**Re: Petition for Reconsideration and Request for Partial Administrative Stay of EPA’s Final Rule:
“Greenhouse Gas Reporting Rule: Revisions and Confidentiality Determinations for Petroleum and
Natural Gas Systems”**

Petition for Reconsideration and Request for Partial
Administrative Stay of EPA's Final Rule: "Greenhouse Gas
Reporting Rule: Revisions and Confidentiality
Determinations for Petroleum and Natural Gas Systems"

Docket ID No. EPA-HQ-OAR-2023-0234

Figure 1: Copied from “Figure 3.1.1 Parity plot for Methane K-values for Data from RR-23, 40, and 193” from Mamrosh et al.

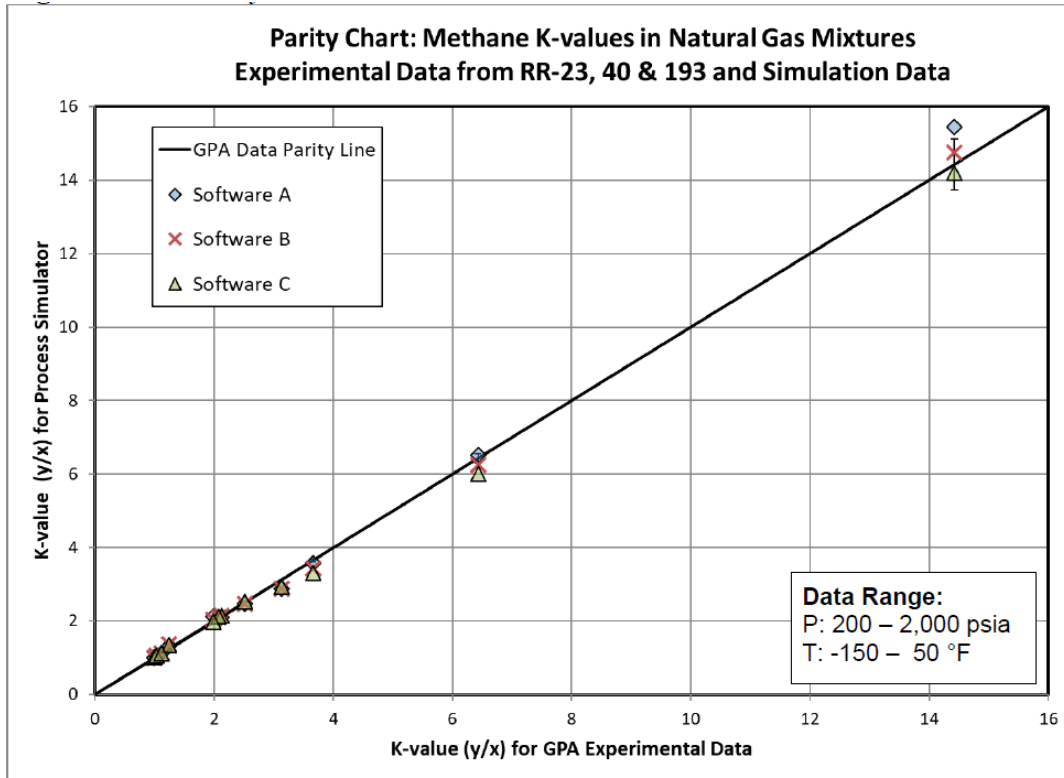
graphed on the x-axis and the simulation value on the y-axis, such that the parity line is the experimental data, and the simulation predictions are the points shown on the graph. In this source, the error bars shown are those of the experimental data. This research report utilizes an equilibrium constant K-value (a representation of solubility) for convenience in comparing Vapor-Liquid Equilibrium data. This shows that process simulators are typically very accurate at predicting methane content from AGRUs.

Figure 2: Copied from “Fig. 2. Simulator vs. operating data for sweet gas CO₂ concentration” in Pieronek et al.

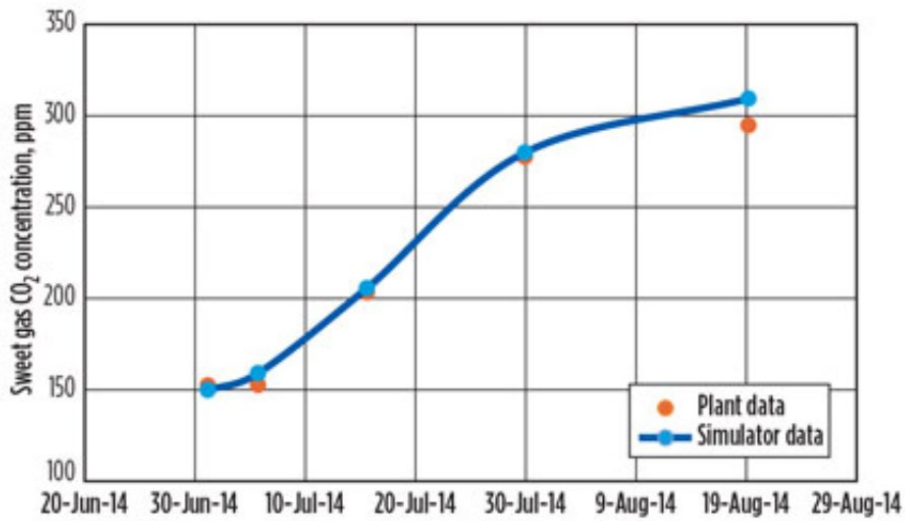
Similarly for CO₂ in AGRUs, the figure below from Pieronek et al.⁶⁵ shows very good agreement between data and simulation.
